24 April 2024
Ref: 5042_610_007

RESPONSE DOCUMENT – MINING LEASE APPLICATION (MC 4541) ERIMAR QUARRY

Response Document to SA Government Departments

TITLE: Site Layout Map

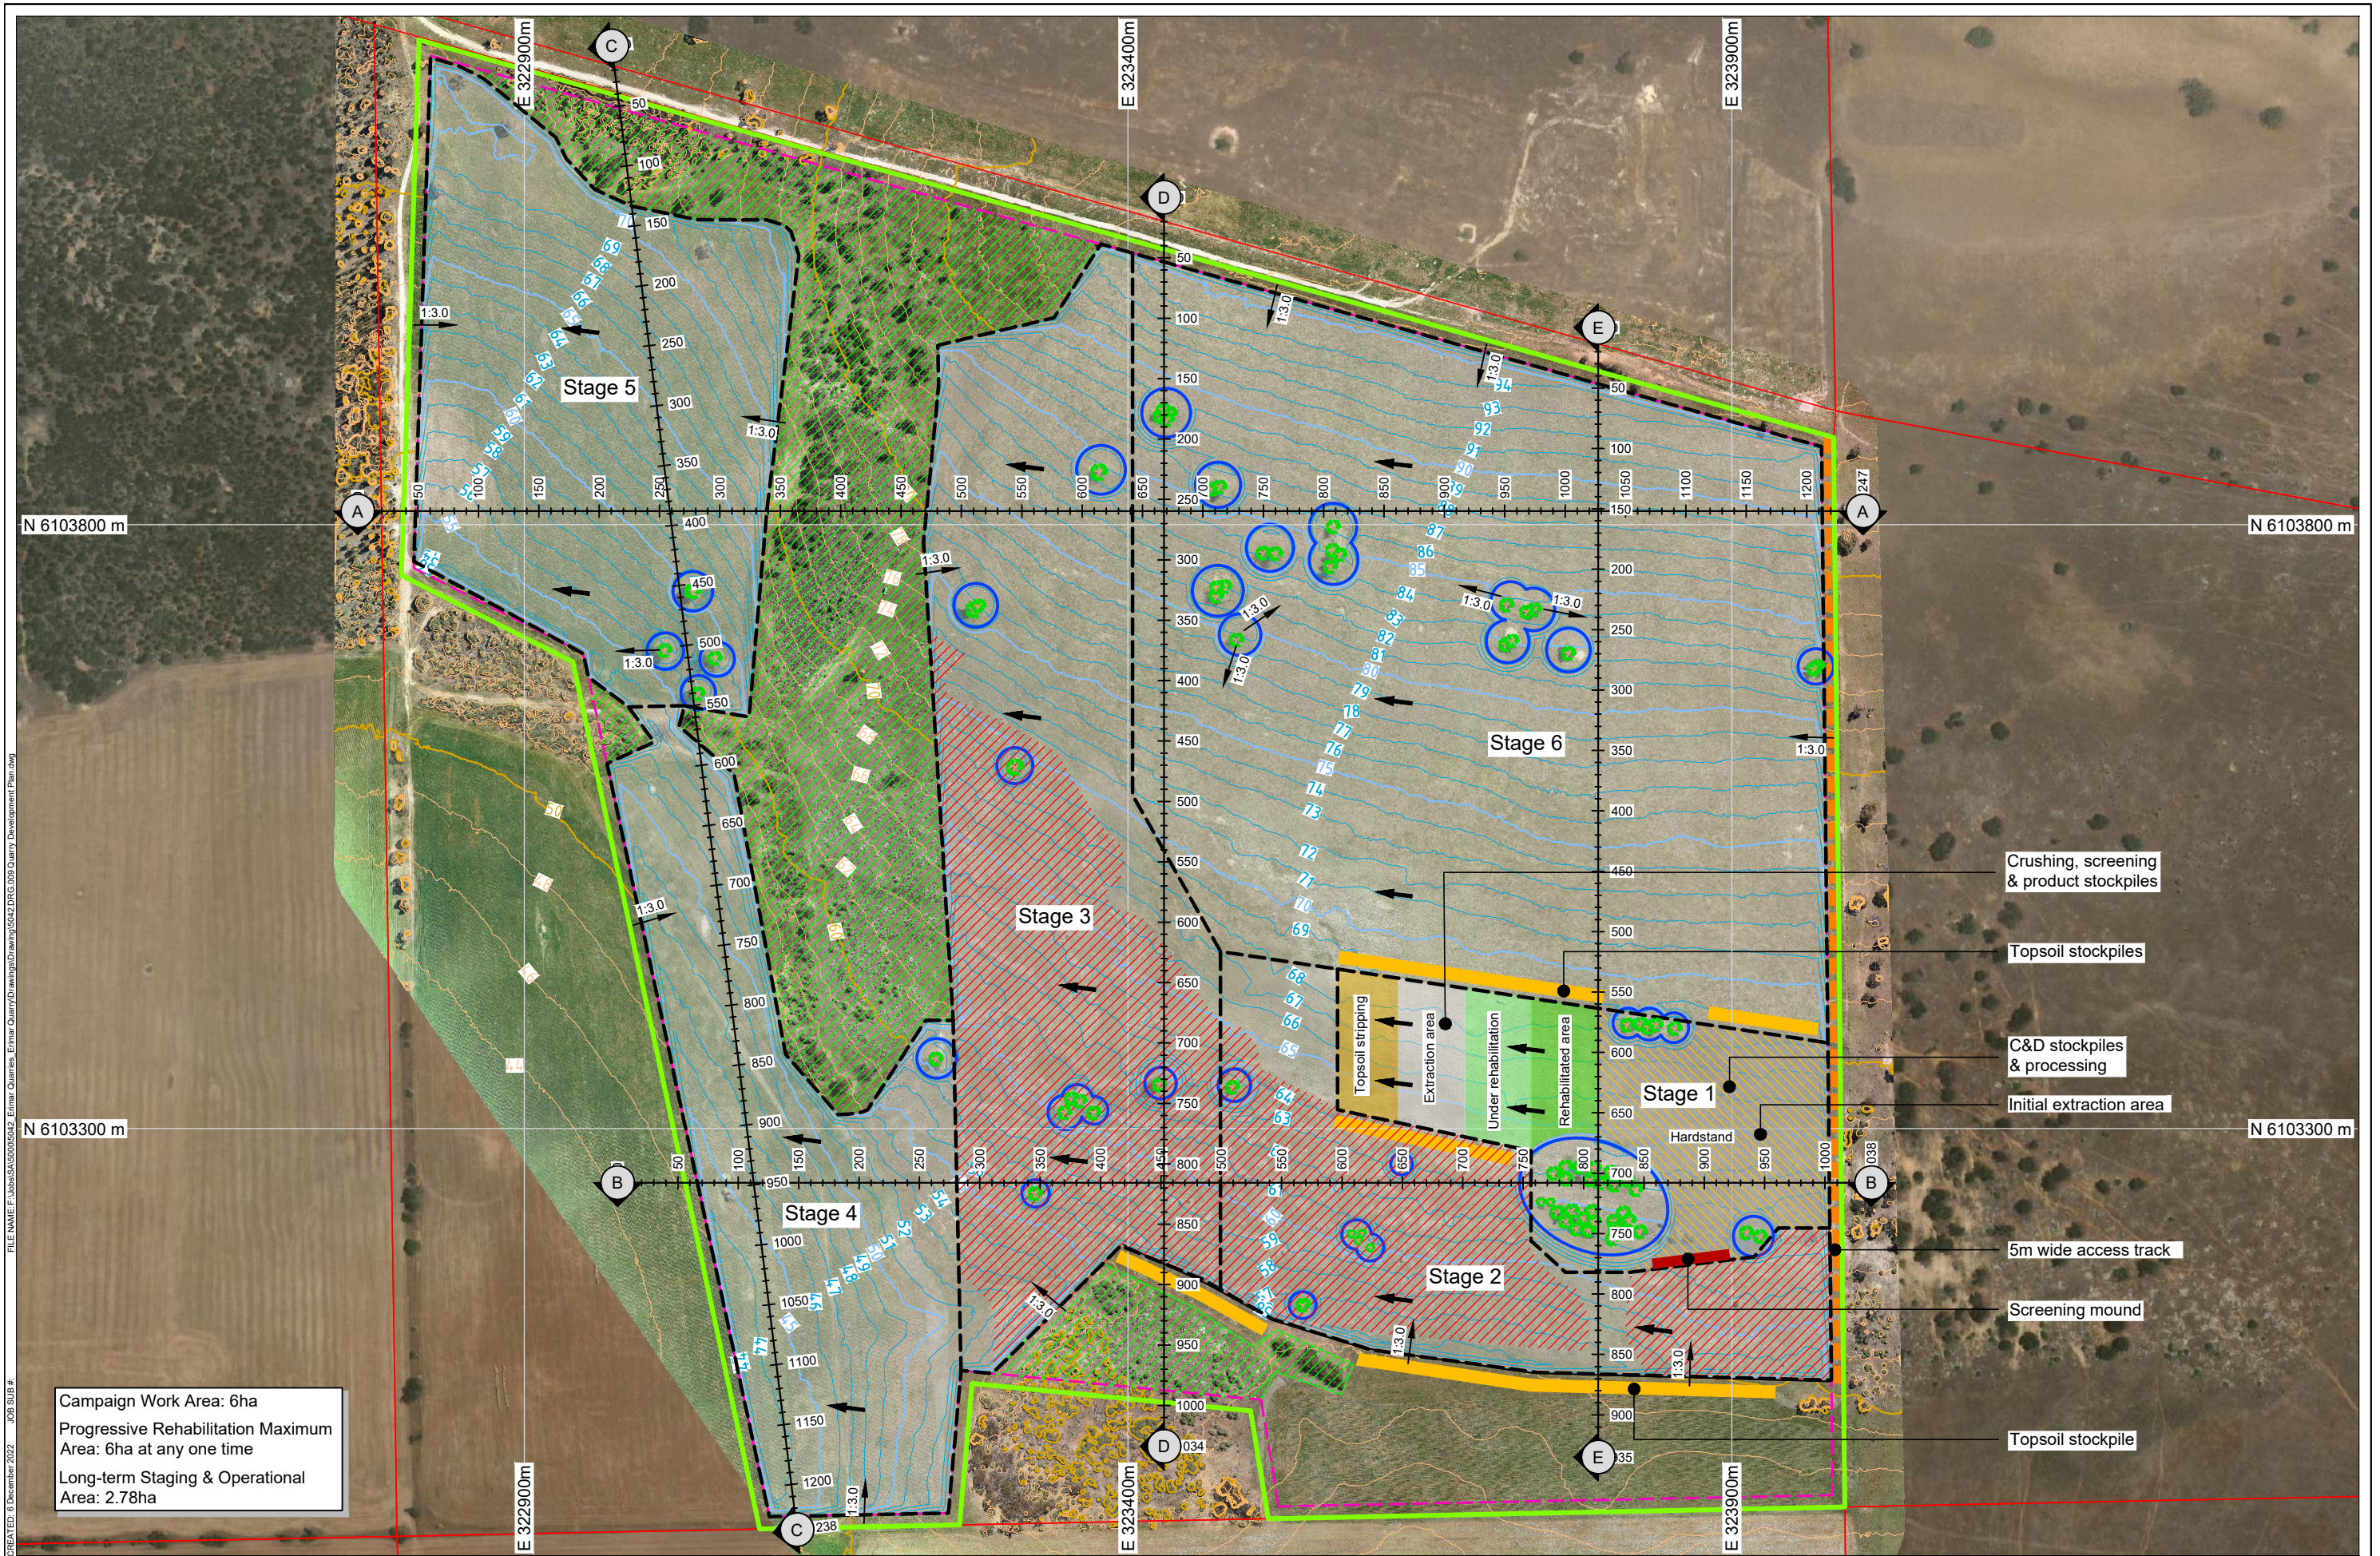
4.1.29 Public Services and Utilities used by the Operation	3.5.3 Public Services and Utilities by the Operation (Water)	- Map 012 – where are the Water Storage tanks supposed to be. Not shown. -Map 006 – No buffer zone shown around your own bore.	The water tanks will be located on the northern portion of the quarry Site in proximity to Water Well 6727-4908, and the map will be updated to show indicative location in the upcoming PEPR. As stated within Section 2.13 Exempt Land of the MLP, Water Well No. 6727-4908 was installed for the purposes of quarry operations, therefore does not trigger exempt land under the <i>Mining Act 1971</i> .

5.5 Industrial and domestic waste	3.4.4 Industrial and Domestic Wastes	<p>* Woodchester doesn't have a shop or a school, so this data is incorrect.</p> <p>* This proposal states this is a 30-year plan for this quarry, but that there are no plans to connect water or electricity in that time. It also states you will be using portable toilets for employees. This is unhygienic and unsanitary for such a long-term plan. This requires further review and planning.</p>	<p>Noted regarding data on the school and grocery store. No material impact.</p> <p>Refer 3.4.4 Industrial and domestic wastes in the MLP: Portable toilets will be used initially through early development of QDP Stage 1 of which a future onsite septic system may be installed as outlined in Drawing No. 5042.DRG.012 – Site Layout Map.</p>

TITLE: Quarry Development Plan

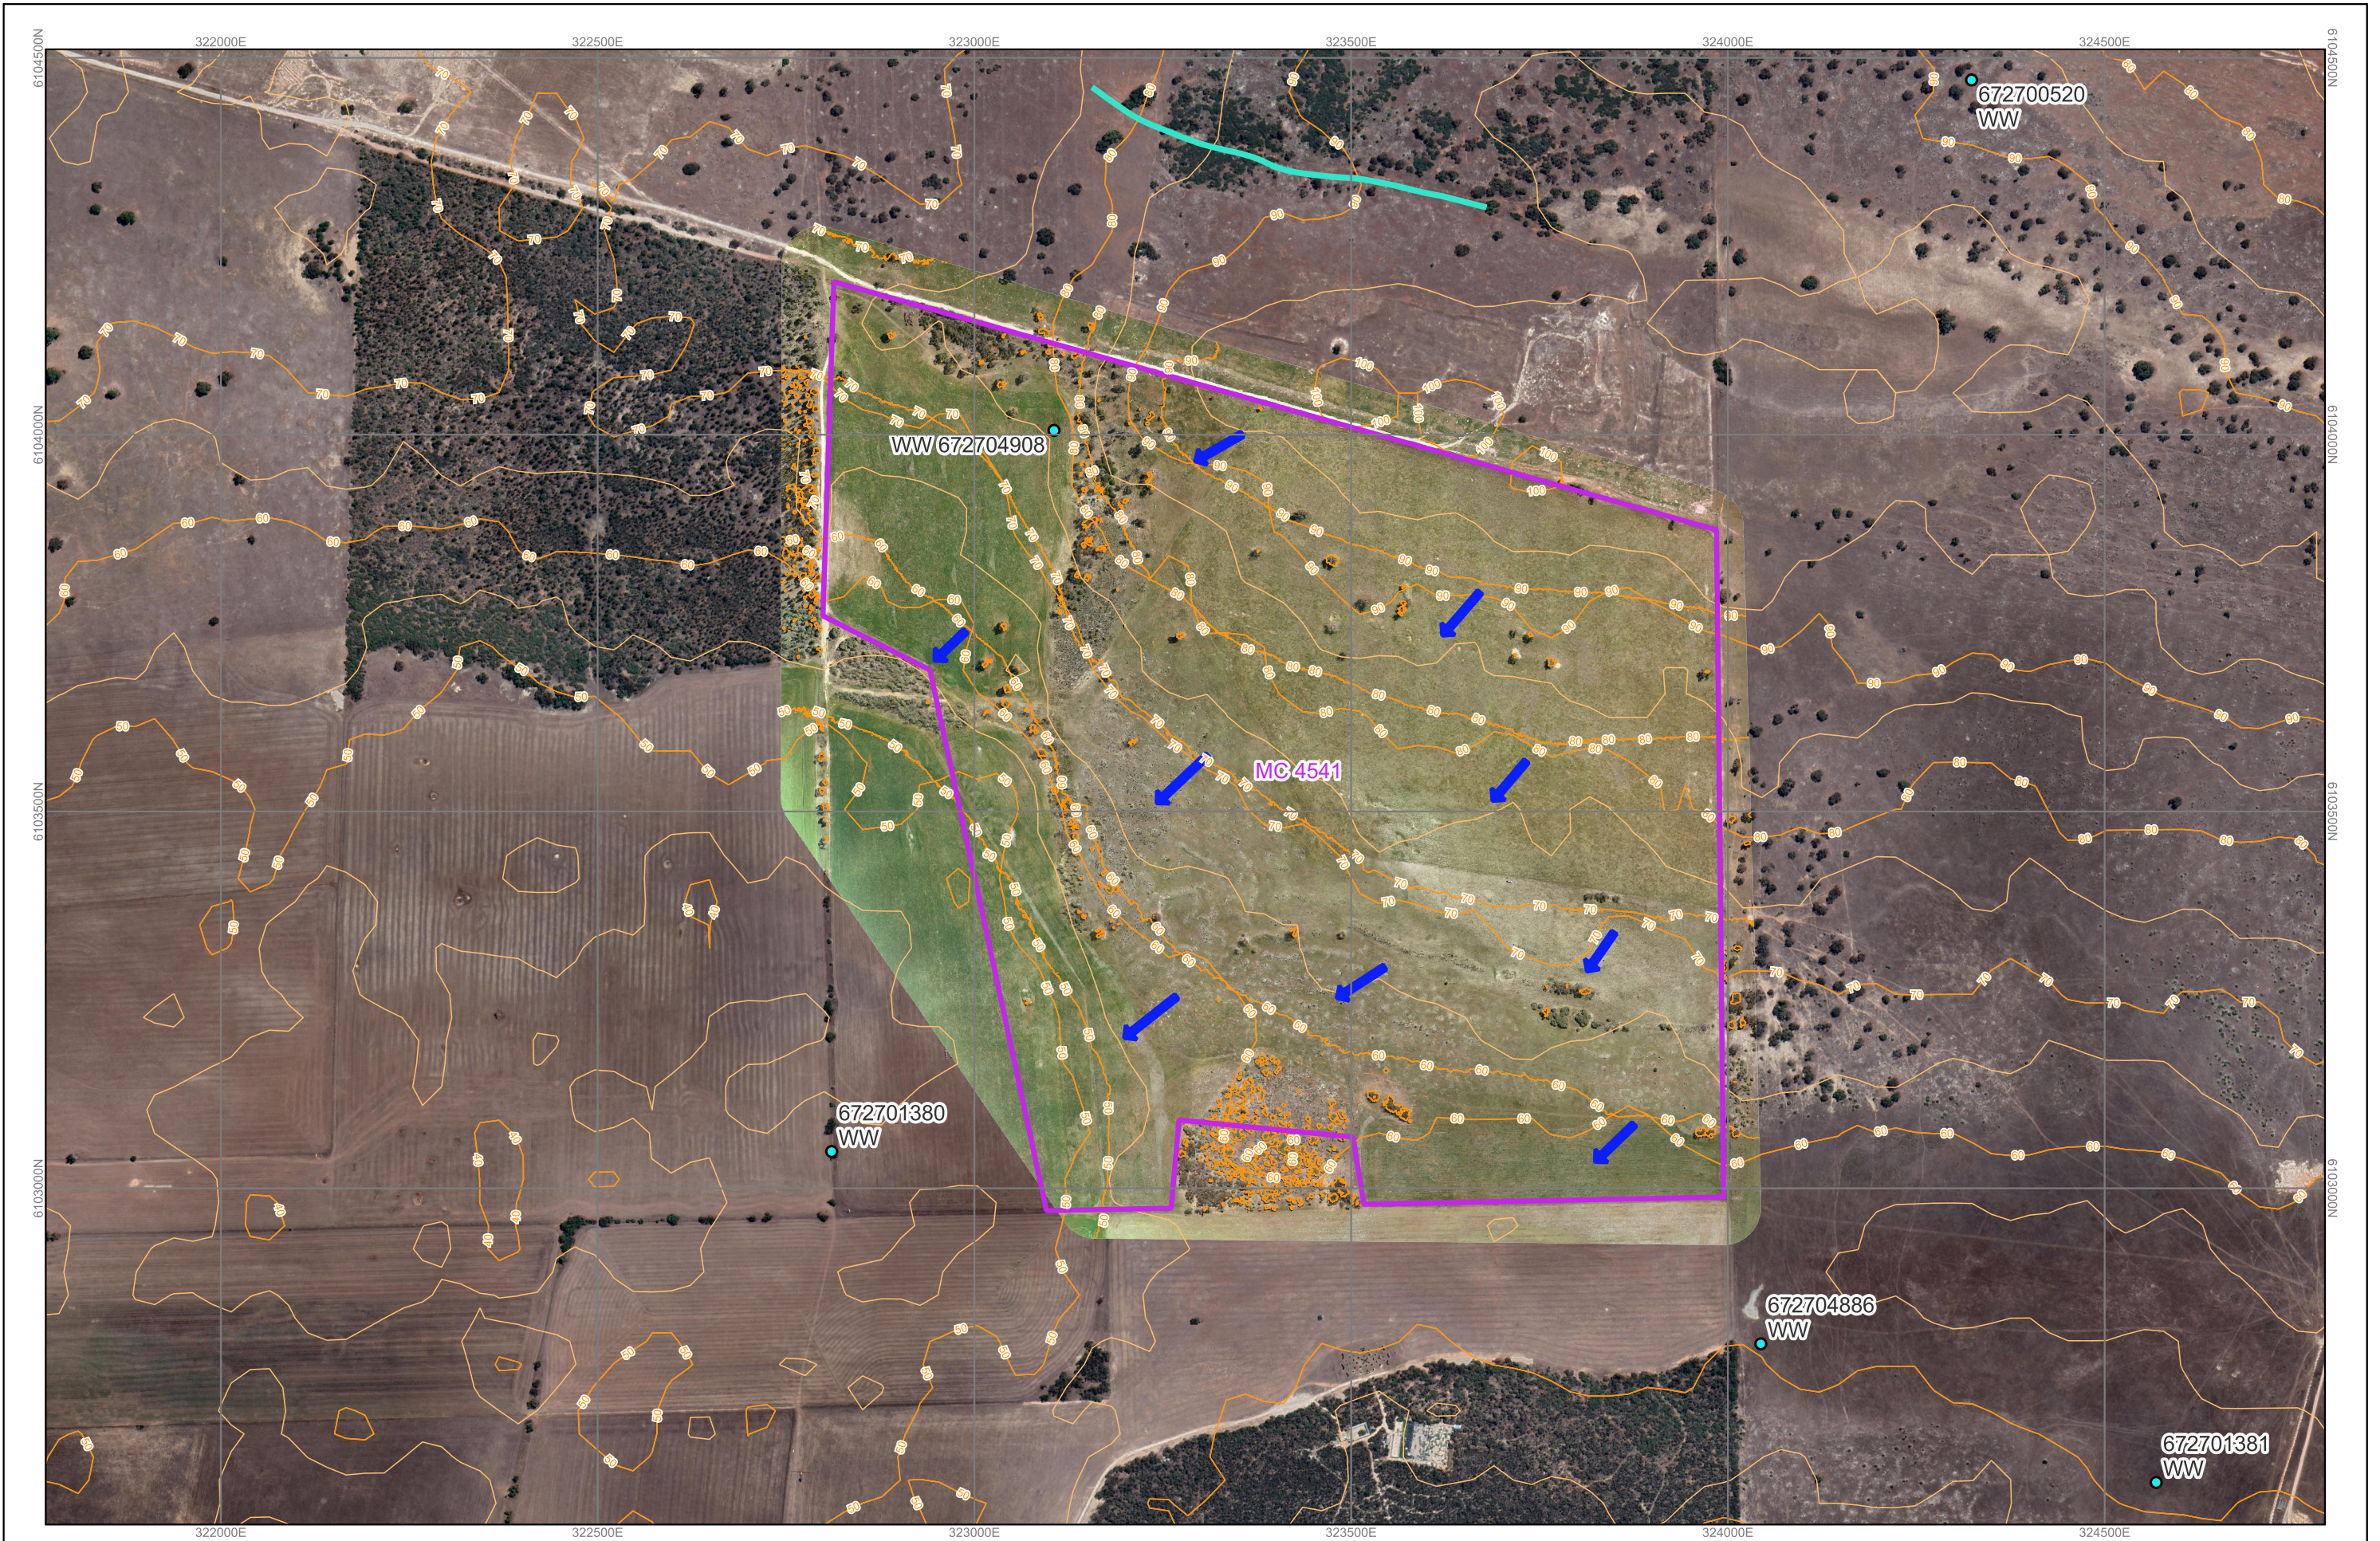
4.1.30 Resource	3.2.1 Resources	-Map 009 Quarry Plan – how long before Stage 3 begins?	Refer response above at Error! Reference source not found.
